Conceptual Design

Wyoming Blvd Pedestrian Study
Casper, WY

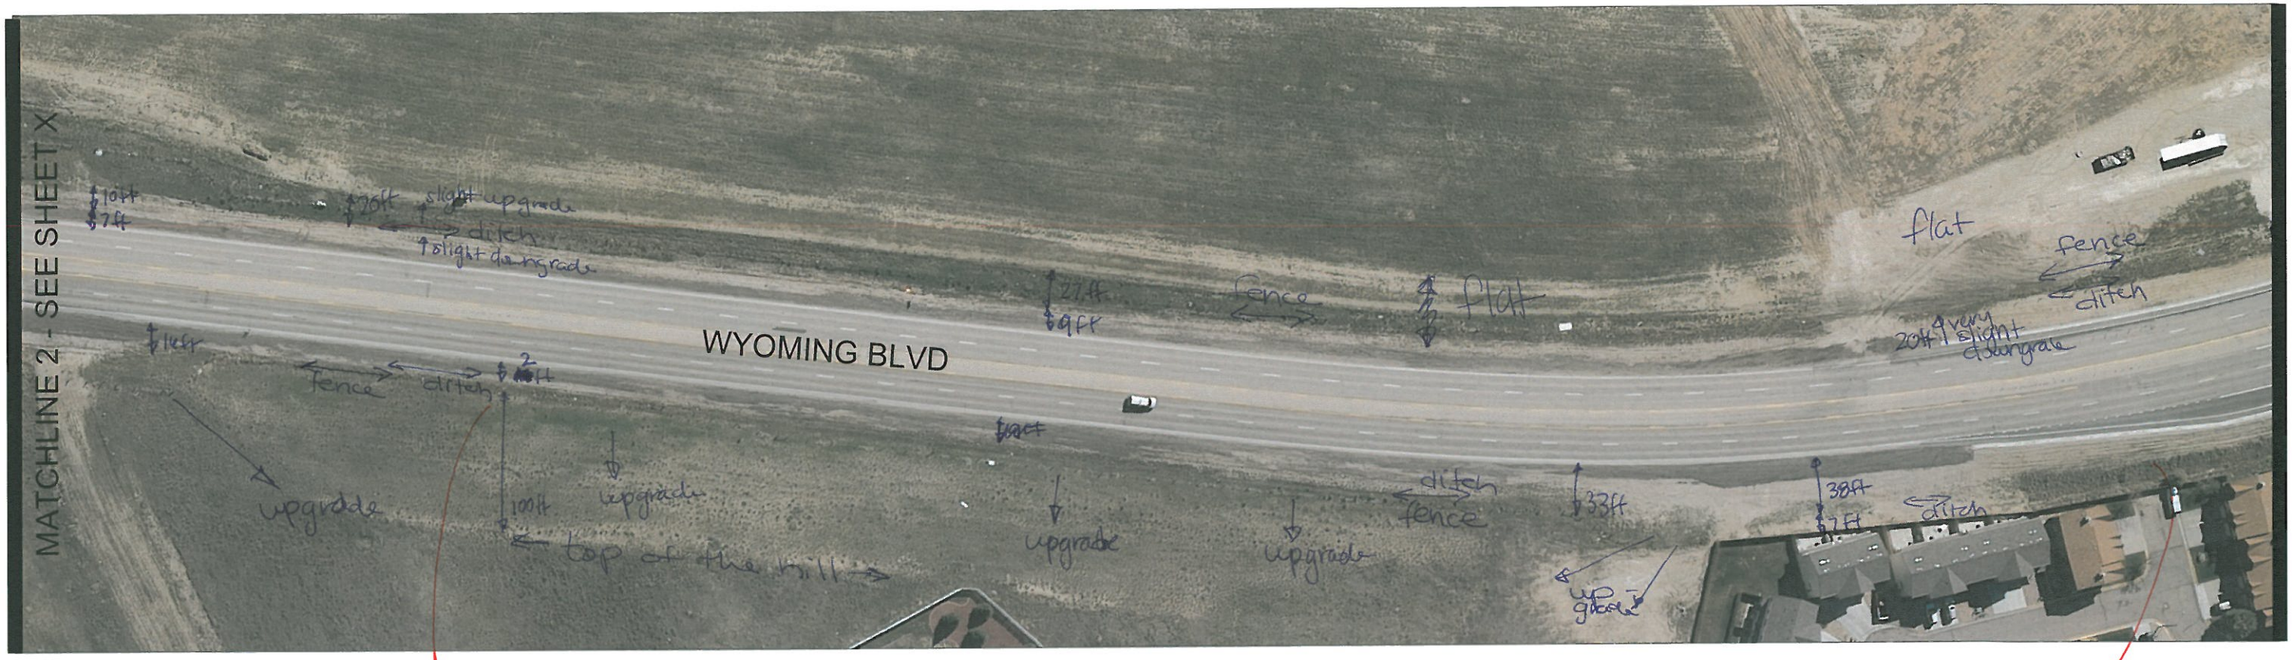
Consider running trail along side of hill (need retaining wall).

Consider keeping trail close to fence. May need some fill due to the ditch.

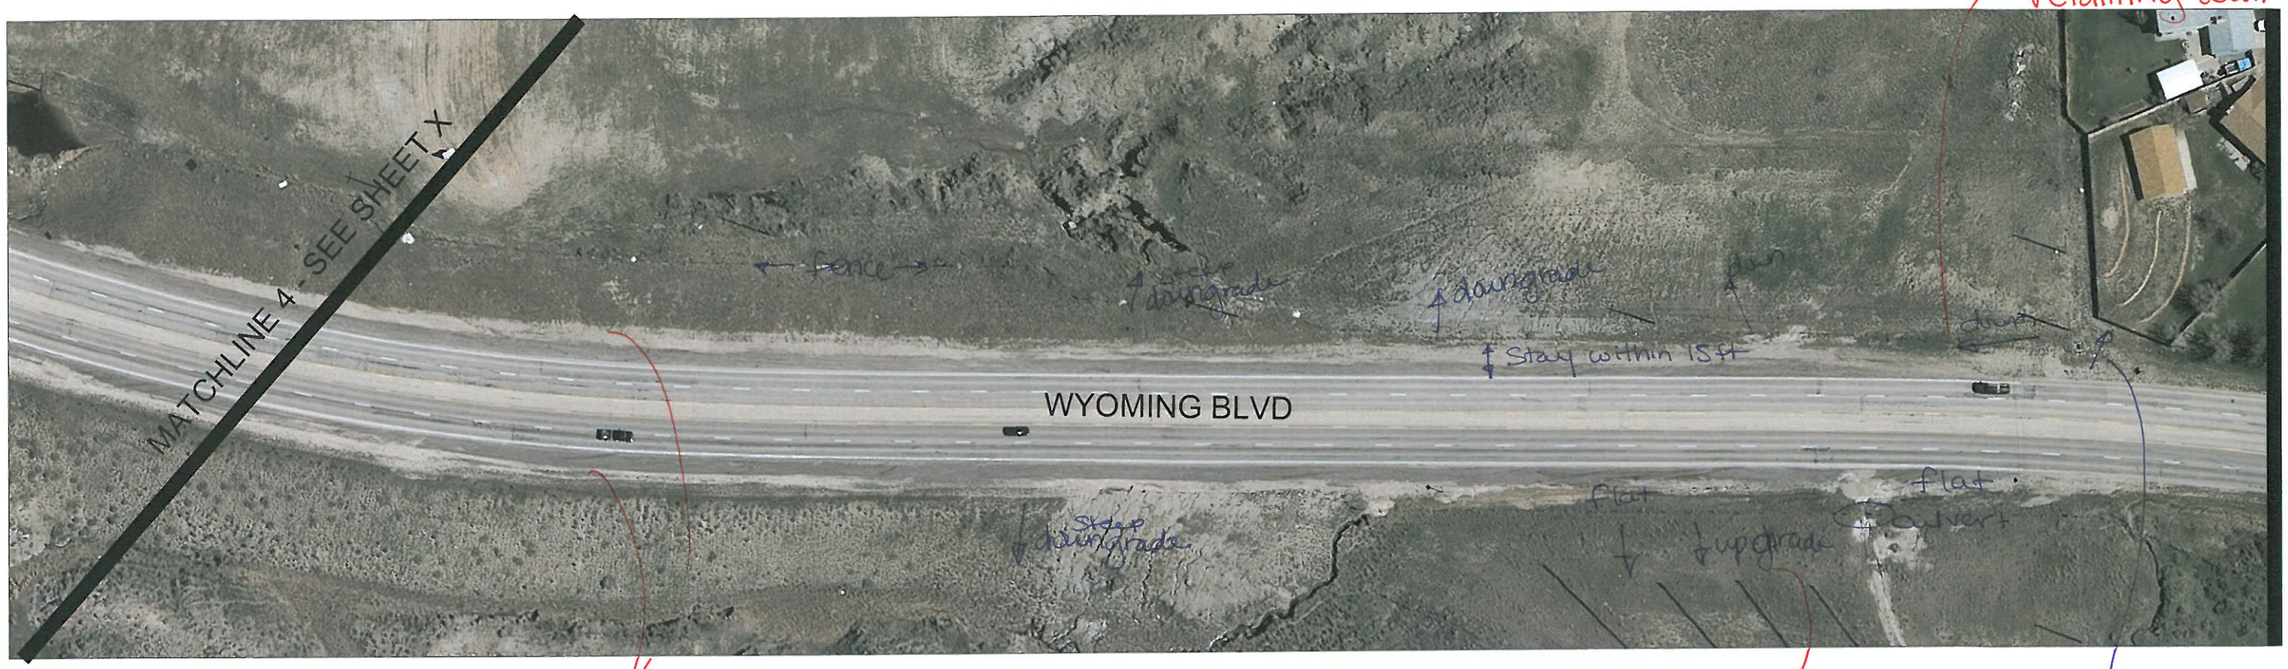
May need retaining wall.

~5% upgrade.

Both sides, consider keeping trail within 15ft of the roadway or filling and placing trail at the fence/ditch

Consider placing trail along road or on hillside

light poles are close to roadway

New driveway and building (see Google)

Concrete ditch
Consider piping. and placing path on top or parallel.

Gas utility box. There looks to be enough space to squeeze in the trail.

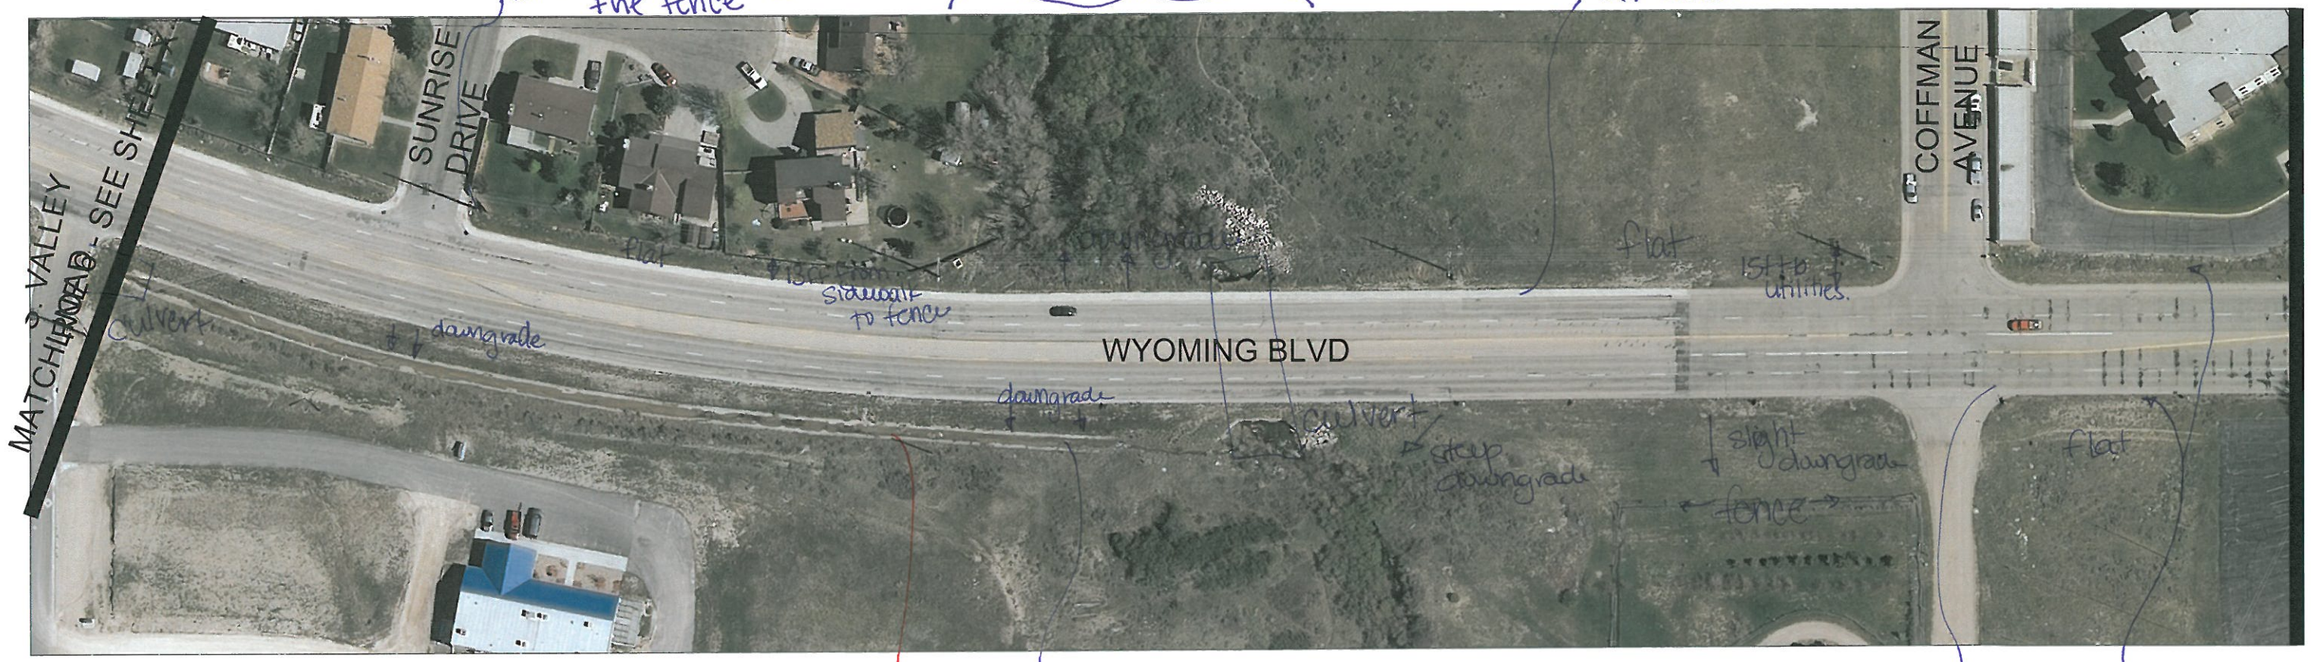
Consider either running trail on S. side of the ditch or pipe the ditch, and put path over. This may require a retaining wall.

there are curb ramps on all 4 corners at intersection

new 5ft sidewalk (attached)

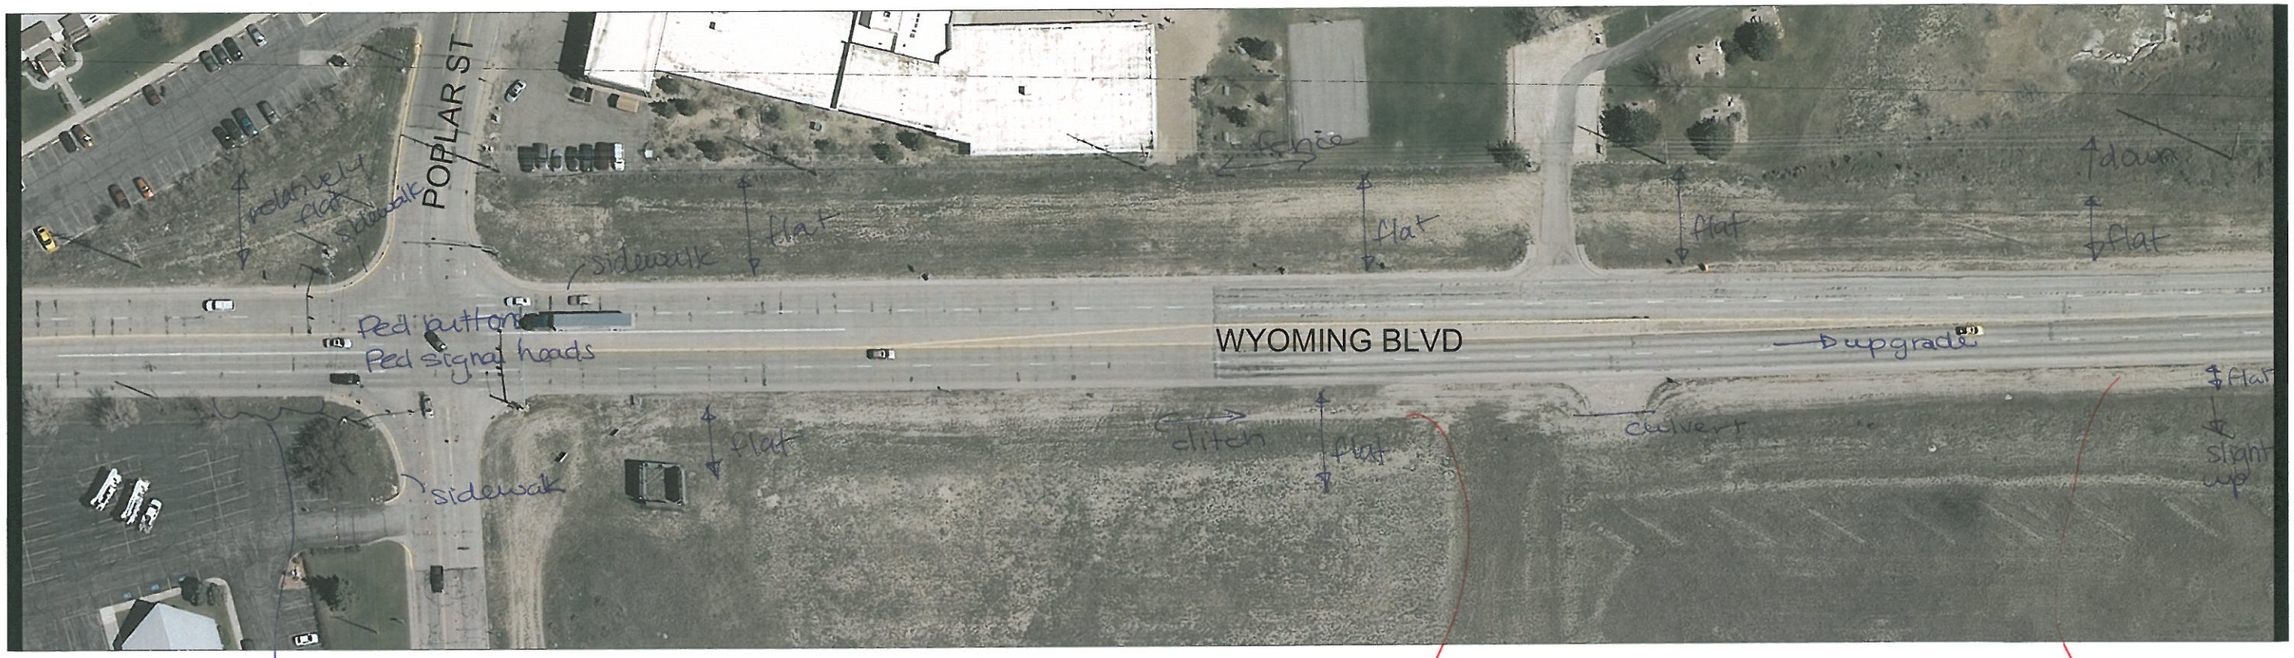
Existing Retaining Wall 2:1 slope to parking lot

Consider placing trail in ditch or along road

Consider an attached trail

Consider keeping trail attached from driveways to up hills.

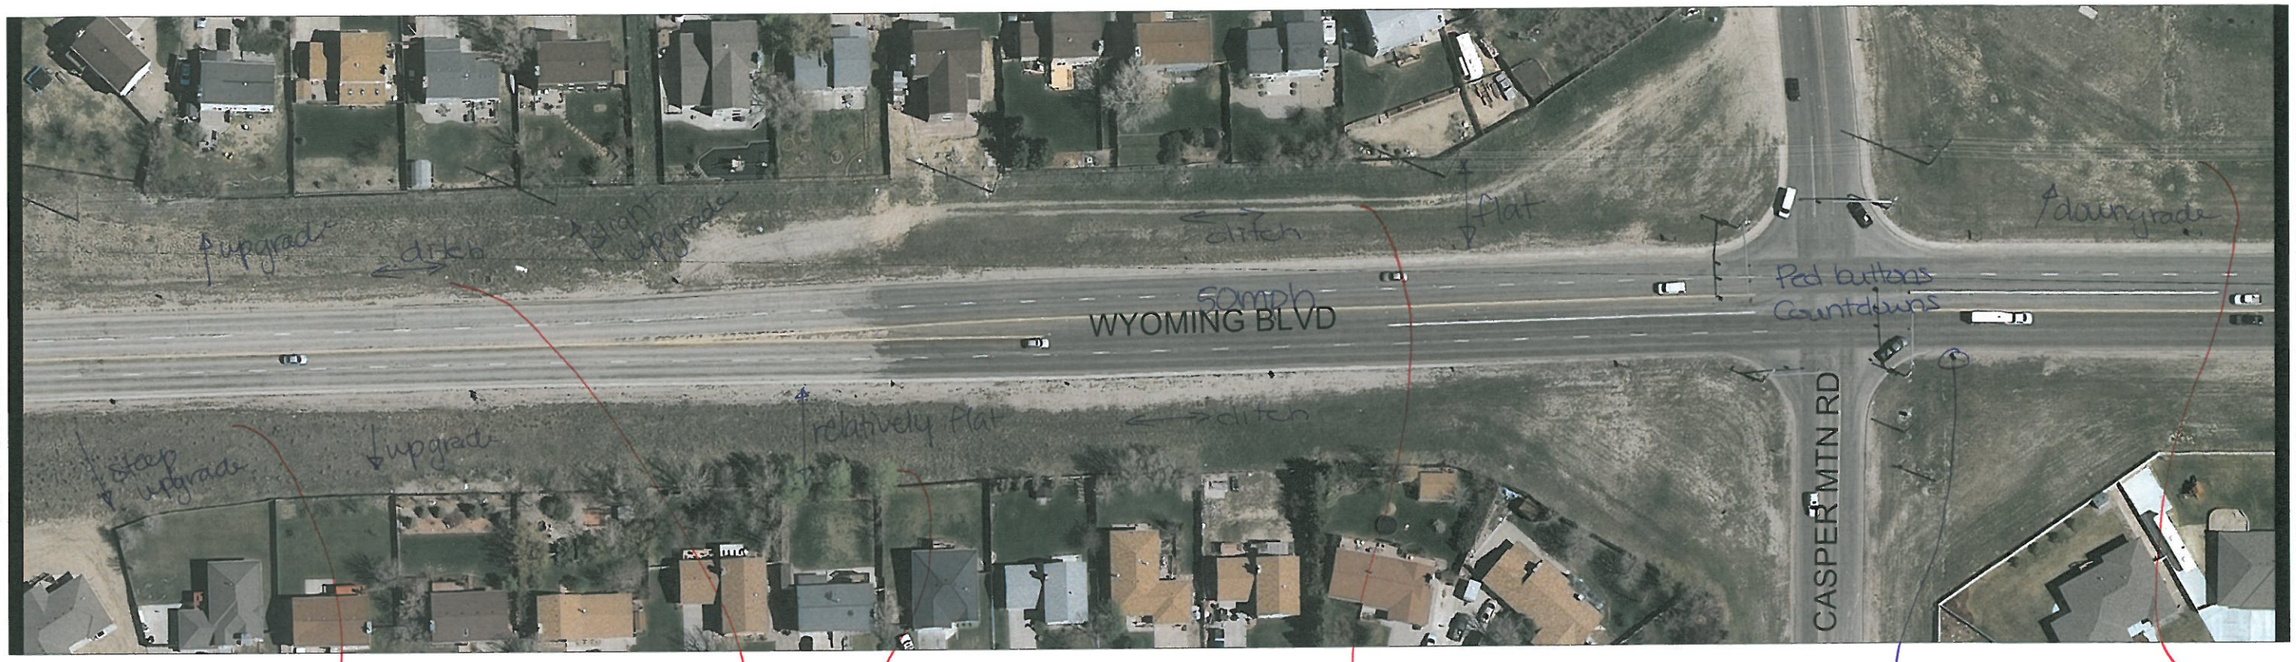
Consider placing trail along roadway or cut in hill

Consider placing trail in ditch (~10ft off road)

Consider placing ~~trail~~ along fence

Consider placing trail along utility easement tracks.

Consider running trail along fence and then bring closer to road at the intersection.

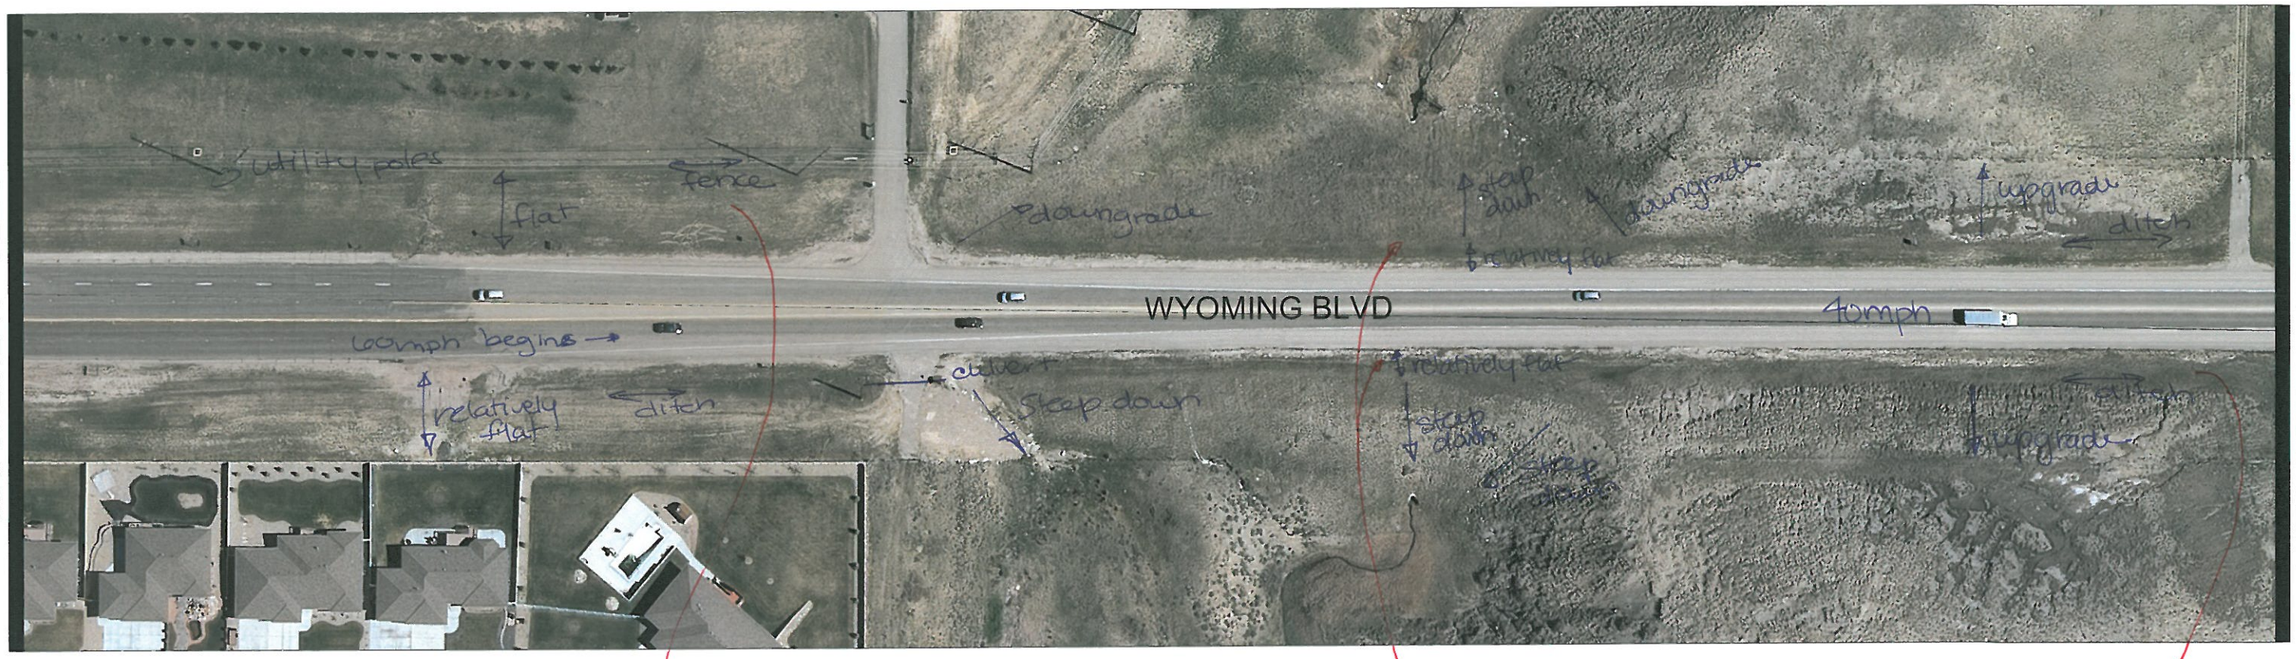
Consider placing trail along the fence. Be cautious of the variety of utilities (gas, fiber, phone). or electric

Consider keeping trail attached to roadway (both sides)

Place trail in the middle of the ditch

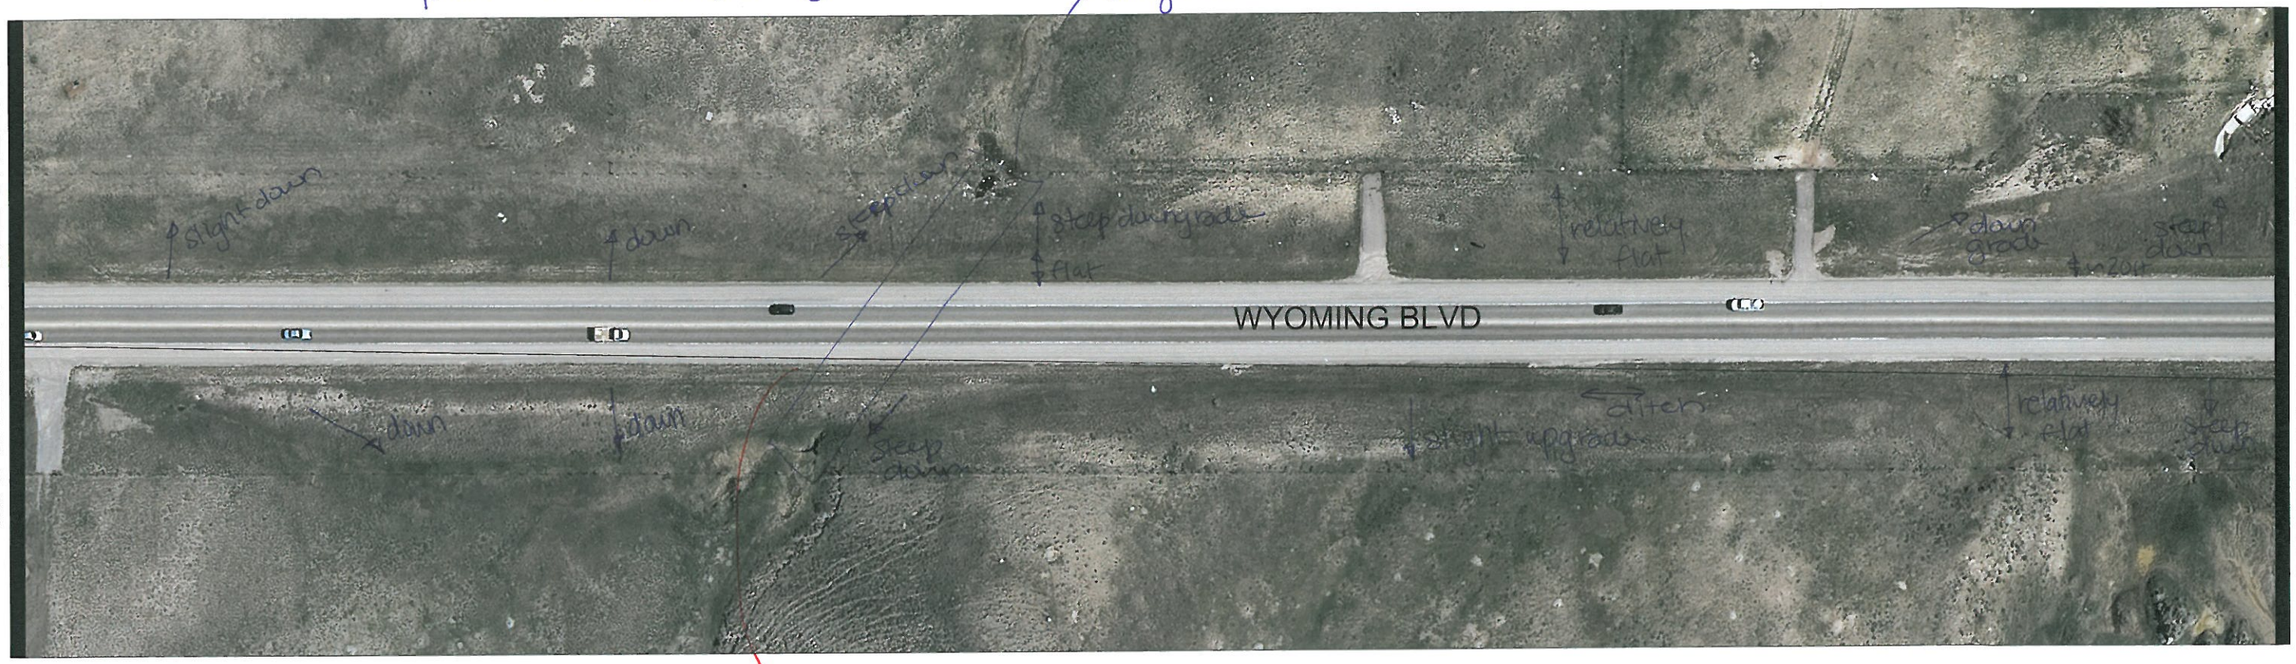
keep trail attached to road @ culvert

keep trail attached to roadway

Consider running trail along the fence. Potentially combine ditch and trail

Consider bringing trail towards road at driveways
